## Product Change Notice (PCN)

PCN Number: **PCN-0450890R-01**

Product(s) Affected: *SJ1-351X-SMT Series (SJ1-3513-SMT-TR, SJ1-3514-SMT-TR, SJ1-3515-SMT-TR, SJ1-3515-SMT-TR-BE, SJ1-3515-SMT-TR-GR, SJ1-3515-SMT-TR-PI)*

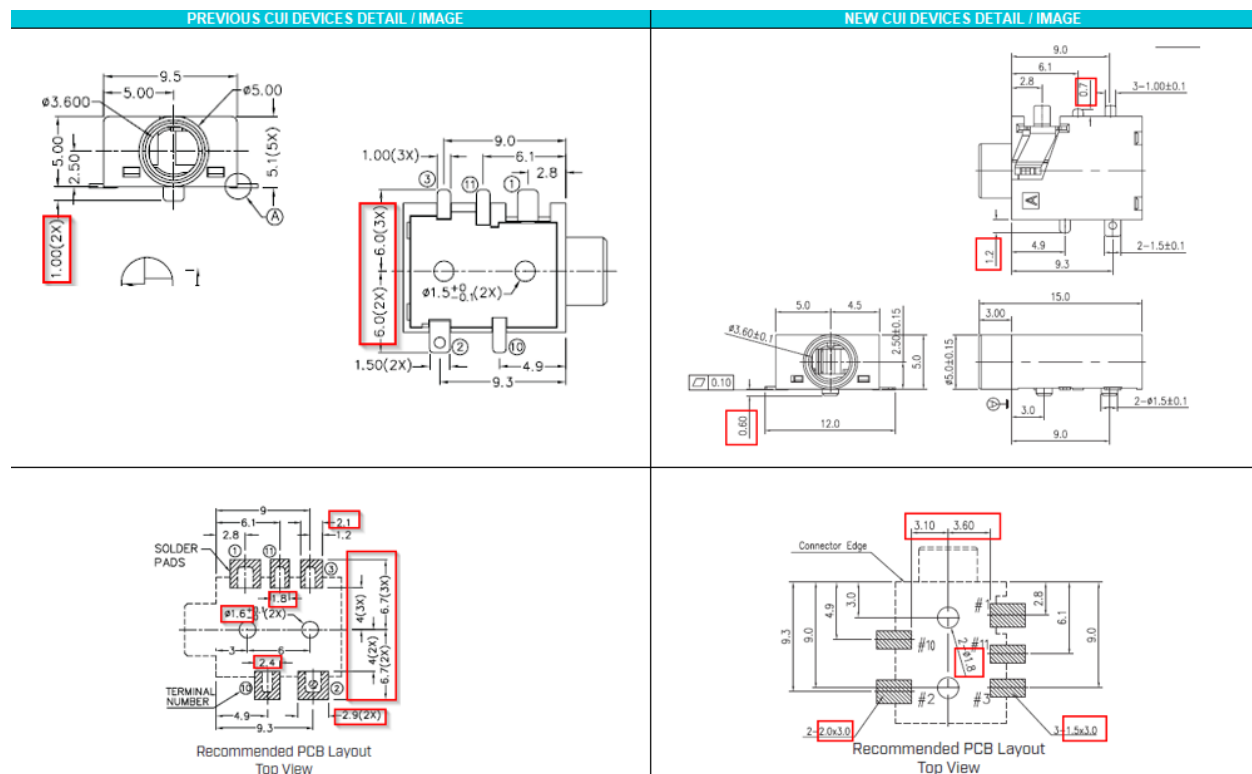
Description of Change: *Minor Housing and footprint differences. Material Change on the housing and terminals. See image Below*

PREVIOUS CUI DEVICES DETAIL / IMAGE			NEW CUI DEVICES DETAIL / IMAGE		
	MATERIAL	PLATING	DESCRIPTION	MATERIAL	PLATING/COLOR
terminal 1	copper alloy	gold flash	terminal 1	phosphor bronze t=0.30	gold flash over nickel
terminal 2	copper alloy	gold flash	terminal 2	phosphor bronze t=0.20	gold flash over nickel
terminal 3	copper alloy	gold flash	terminal 3	phosphor bronze t=0.20	gold flash over nickel
terminal 10	brass	gold flash	terminal 10	brass t=0.20	gold flash over nickel
terminal 11	brass	gold flash	terminal 11	brass t=0.20	gold flash over nickel
plastic	PA10T		cover	PAST [UL94V-0]	see color options
			housing	PAST [UL94V-0]	see color options
